Access Compliance Report Public Rights-of-Way (Curb Ramps)

Intersection ID: 49689 Main Street: ALEXANDER_ALLEY_DR Cross Street: SHARON_HILLS_RD Location: N

ADA ID: 7DD64F8434C4 Ramp Type: PerpDiag Initial Pass/Fail: Pass Overall Compliance: No Severity Score: 2.75

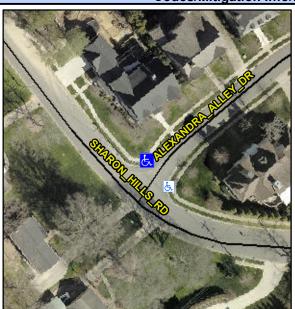
SHARON HILLS RD None ALEXANDER ALLEY DR StopSign Remove & Replace Curb Ramp With Two New Directional Ramps or Equivalent. Remove & Replace Gutter.

PROW/ADA:
Not Found, R304.5.3, R304.2.2-Perp, R304.3.2-Para, R304.2.3

Comp	Compliance Description		Compliance		Description	Data
N/A	Ramp Length (in)	49.0	Yes	Ramp	Slope (%)	7.5
Yes	Ramp Width (in)	48.0	No	Ramp	XSlope (%)	4.8
N/A	Flare Type LT	Sloped	N/A	Flare	Type RT	N/A
N/A	Flare Slope LT (%)	0.9	No	Flare	Slope RT (%)	10.6
N/A	Flare Traversable LT?	Yes	N/A	Flare	Traversable RT?	Yes
Yes	Landing Length (in)	49.0	Yes	DWS	Provided?	Yes
Yes	Landing Width (in)	48.0	Yes	DWS	Contrast?	Yes
No	Landing Slope (%)	2.2	Yes	DWS	Length (in)	24.5
No	Landing X Slope (%)	5.3	Yes	DWS	Full Width?	Yes
N/A	Landing Curb? (Y/N)	No	Yes	DWS	Offset (in)	0.0
N/A	Shared Landing?	No				
Yes	Gutter Ponding?	No	Yes	Gutte	r Slope (%)	0.4
Yes	Gutter Lip Ht (in)	0.0	No	Gutte	r X Slope (%)	3.3
N/A	Painted X Walk1?	No	N/A	Paint	ed X Walk2?	No
	X Walk 1 Direction	To SW		X Wa	lk 2 Direction	To SE
N/A	X Walk 1 Width (in)	N/A	N/A	X Wa	lk 2 Width (in)	N/A
	X Walk 1 Slope (%)	4.1		X Wa	lk 2 Slope (%)	2.1
	X Walk 1 X Slope (%)	0.8		X Wa	lk 2 X Slope (%)	3.2

Possible Solutions:
